### Staff Report & Recommendation

### Historic Preservation Board

SUBJECT: HPB20-0387, **334 Ocean Drive.**

An application has been filed requesting a Certificate of Appropriateness for design modifications to the lobby and to the east façade of the building, including the introduction of a new canopy structure and variances from the minimum hotel unit size required and from the front and side setbacks.

*334 Ocean Drive, east elevation, permit no. 15724*

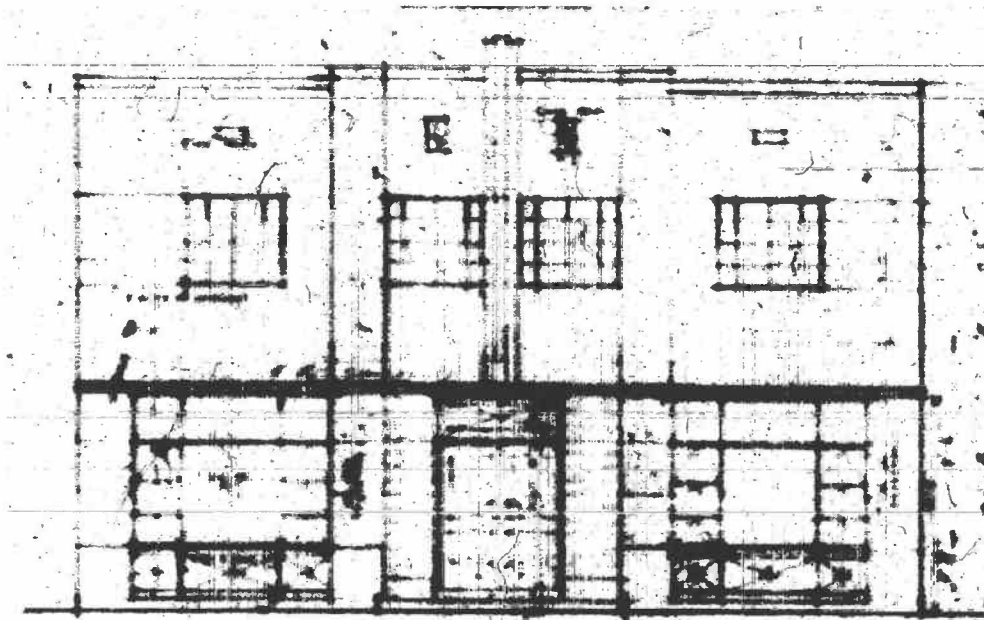
Along the primary (Ocean Drive) facade, the applicant is proposing to remove the existing approximately 18" continuous concrete eyebrow and attached metal awning to be replaced by a new canopy structure. The new bronze color canopy is attached to the building in the same location as the concrete eyebrow and extends approximately 5'-0" to the front property line. The canopy is supported by four sets of three metal columns that attach to the existing porch railing.

While having no objection to the introduction of a new canopy at this location, staff is concerned with the proposed demolition of the eyebrow feature, which is an original architectural element. As such, staff recommends that the eyebrow be retained and incorporated into the new canopy structure. Additionally, staff recommends that the color of the canopy be consistent with metal finishes of the Art Deco era including clear anodized aluminum, silver or mid to light bronze. Finally, staff recommends that any proposed lighting fixtures, fans, sprinkler pipes etc. that are attached to the canopy be fully integrated into the structure with no exposed conduit or piping.

- b. The preserved moss shall not be permitted to be installed on the Ocean Drive facade.
  - c. The existing continuous eyebrow structure shall be retained or reconstructed. Any new canopy structure shall integrate the eyebrow, in a manner to be reviewed and approved by staff consistent with the Certificate of Appropriateness Criteria and/or the directions from the Board. The finish of the new canopy shall be clear anodized aluminum or powder coated grey, silver or light bronze.
